PLANNING BOARD AGENDA

**SEPTEMBER 14, 2026
REGULAR MEETING**

Re: Borough of Lake Como Planning/Land Use Board
Application by Harry Craig Froonjian and Renee Froonjian
318 17th Avenue, Lake Como, NJ 07719
Block 1, Lot 9, Borough of Lake Como
Bulk Variance Development Application

**Re: Completeness/Technical Review #2
Torielli Variance Application
1603 Newman Street
Block 10, Lot 17
H2M Project No. LKCP 2603**

A-103

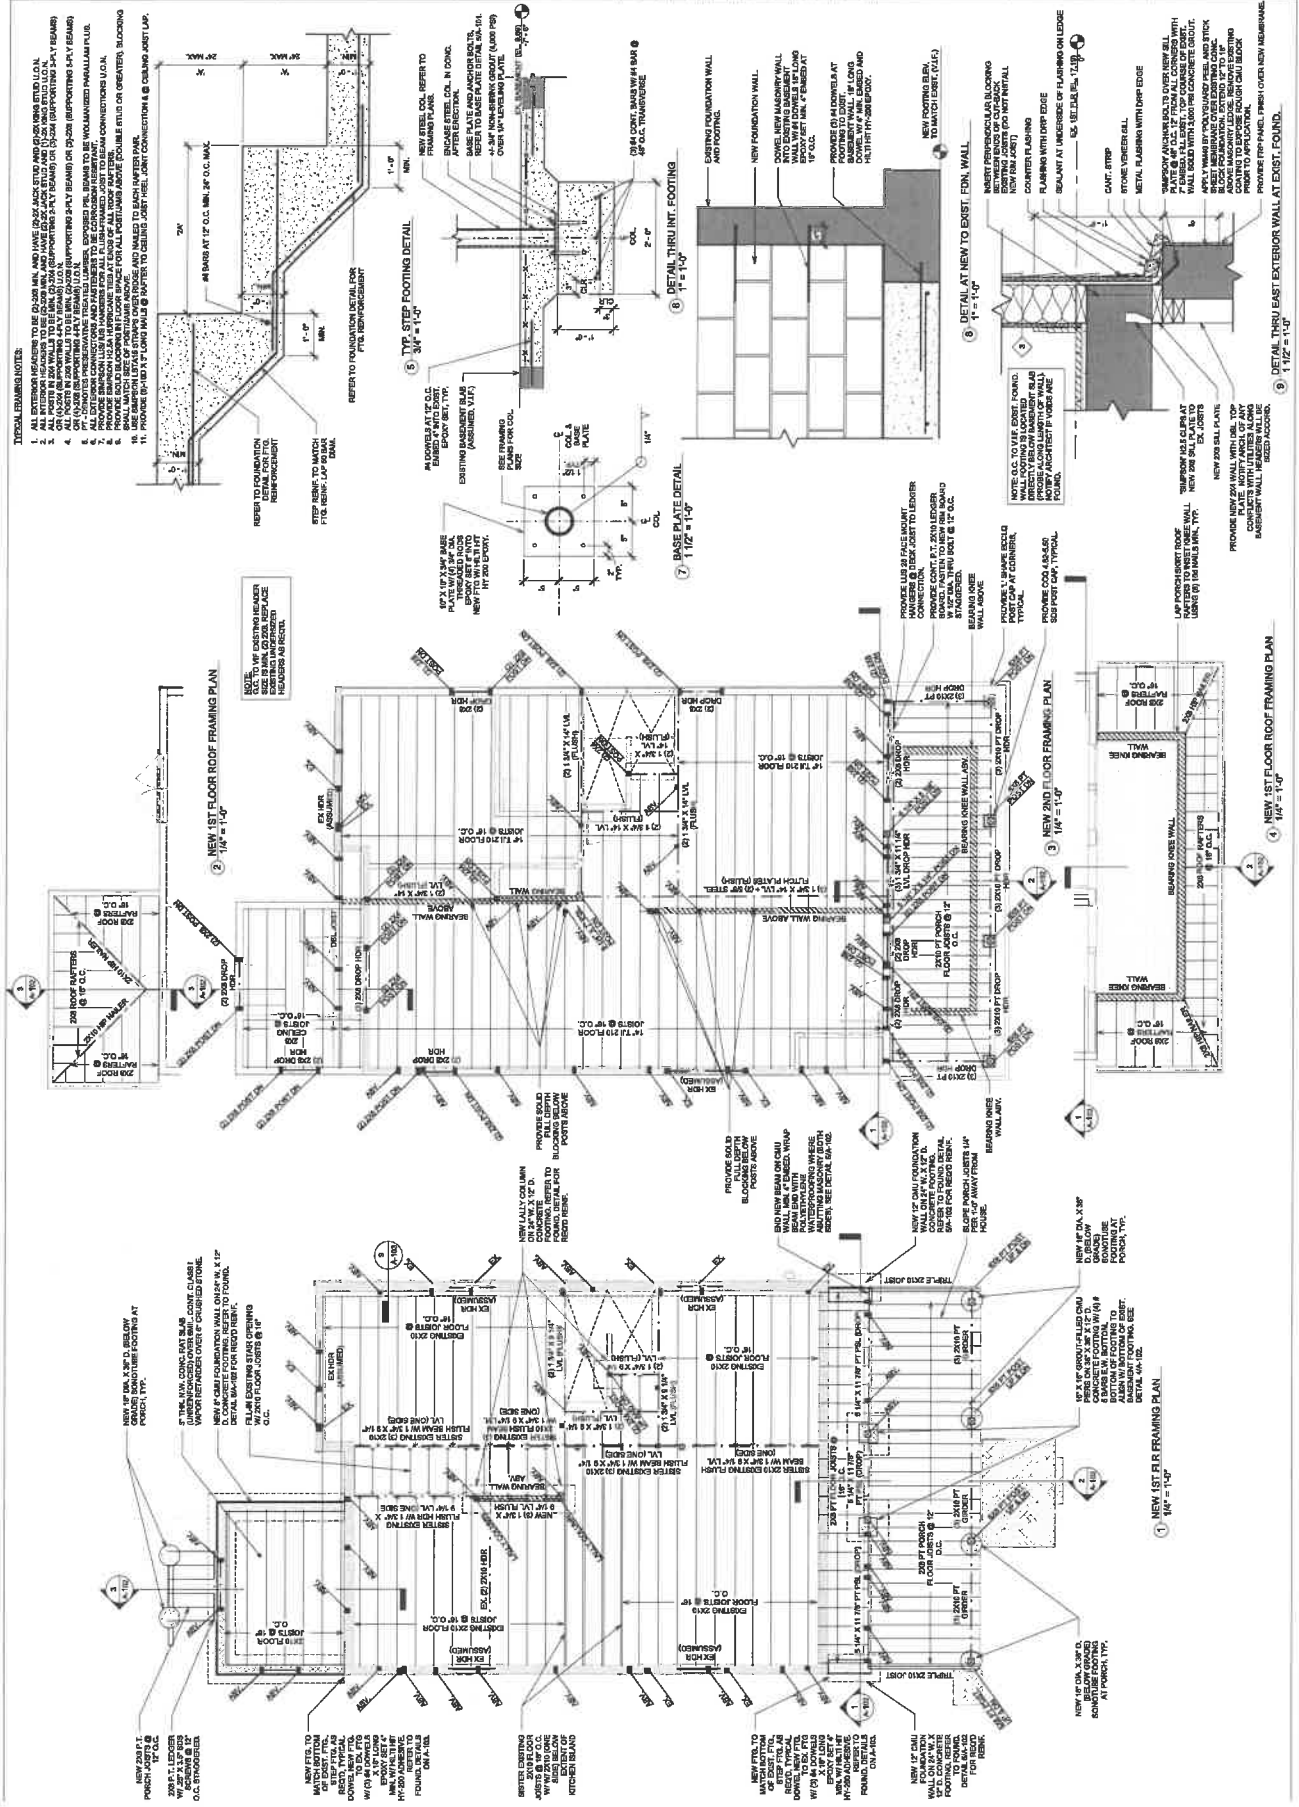
1. Plans do not detail how the reconstruction of the easterly wall will achieve the requisite side yard setback while relying on the existing non-conforming foundation wall;
2. Cannot replicate the half-story calculations. My math indicates an allowable half-story of 526.5 sf and the plans provide for interior space of 569 sf;
3. Not sure how the driveway can work physically without being expanded; however, the shared drive with the neighbor is already in excess of the allowable cut (20'+/- existing where 16' max allowable); and
4. Still have the question of the legality of the non-conforming shed (was a permit sought?).

1. Plans do not detail how the reconstruction of the easterly wall will achieve the requisite side yard setback while relying on the existing non-conforming foundation wall; The conforming detail is shown on A-103 drawing #9, bottom right corner of the sheet.

PLOT PLAN
 LOT 17 BLOCK 10
 BOROUGH OF LAKE COMO
 MONMOUTH COUNTY, NEW JERSEY

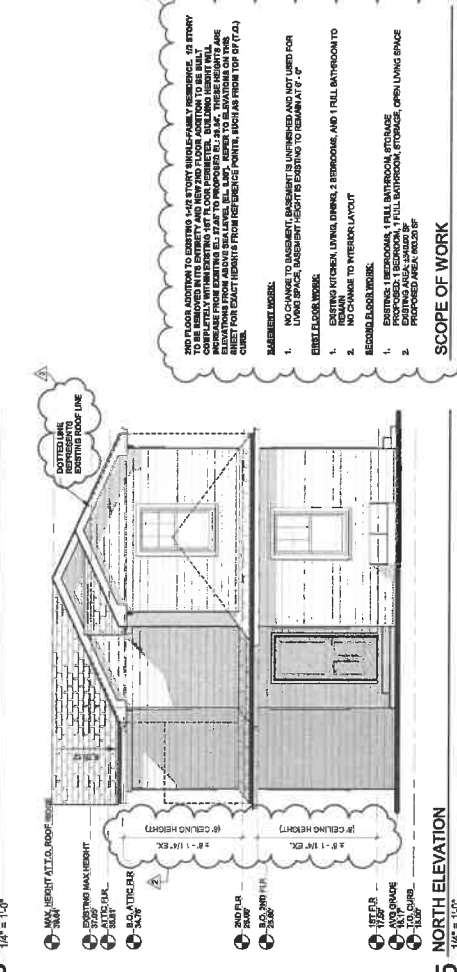
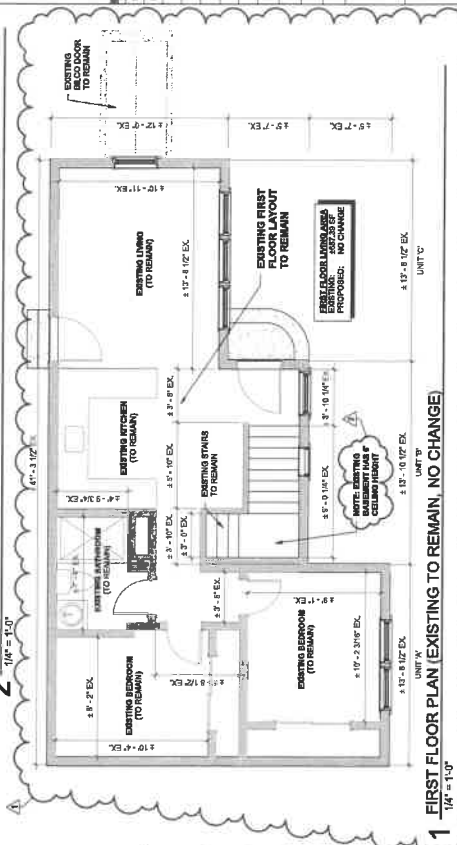
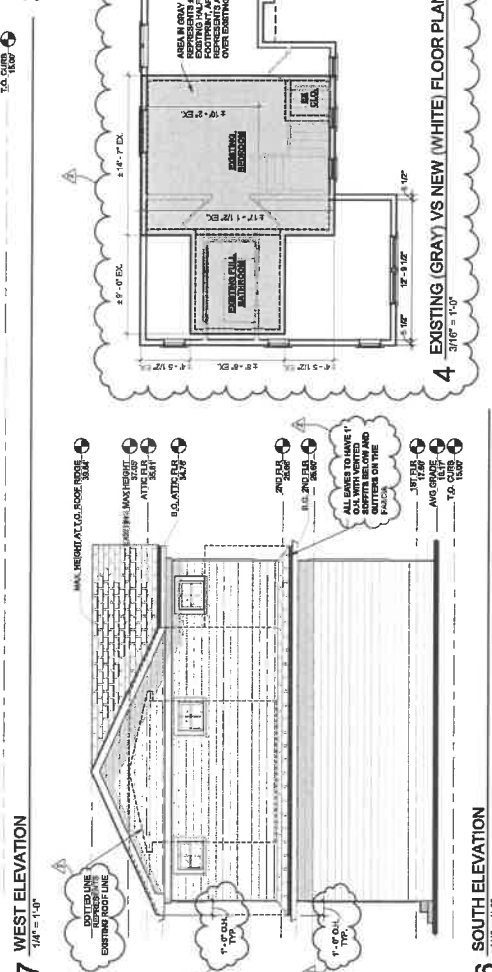
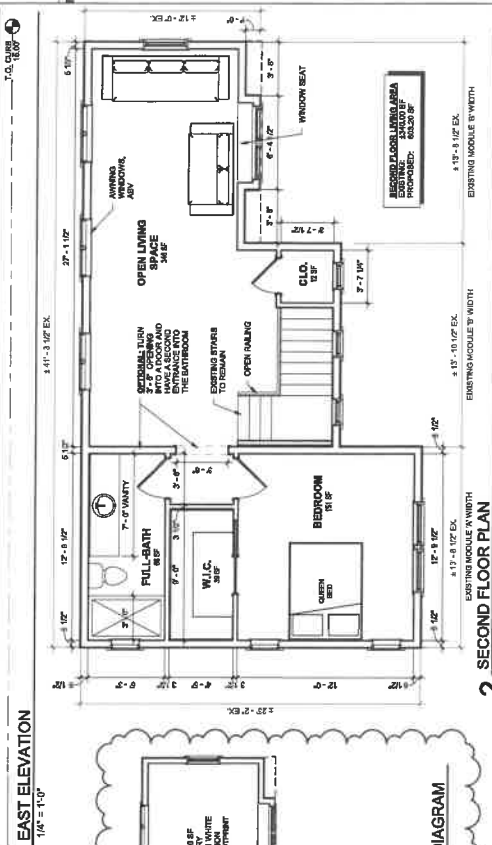
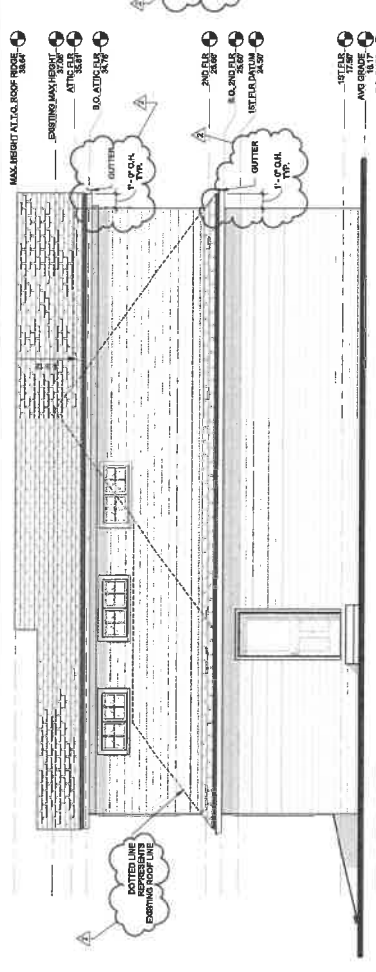
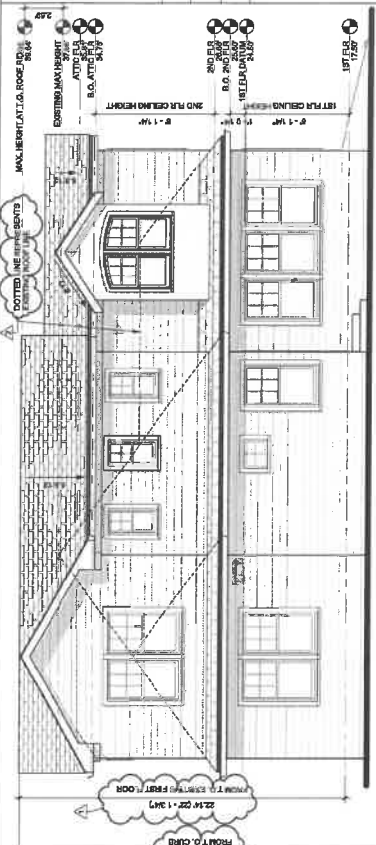
5. The rear paver patio extends beyond the limits of the subject property. The Board should condition any approval on the modification of the paver patio to fit within the identified property limits.

6. **Both of the drywells depicted on the Plot Plan do not conform to Borough Ordinance 2024-01. The smaller of the two drywells does not achieve the 40 cubic foot minimum of volume. Both drywells do not have two feet of cover, and both are less than 10 feet from the principal dwelling. Additionally, the Plot Plan depicts connections to the drywells, however, it is unclear how much runoff each drywell receives in a rainfall event. A breakdown of how much runoff each drywell receives should be provided to ensure the drywell is in conformance with the Ordinance. The Plot Plan should be revised to be in conformance with Borough Ordinance 2024-01.**
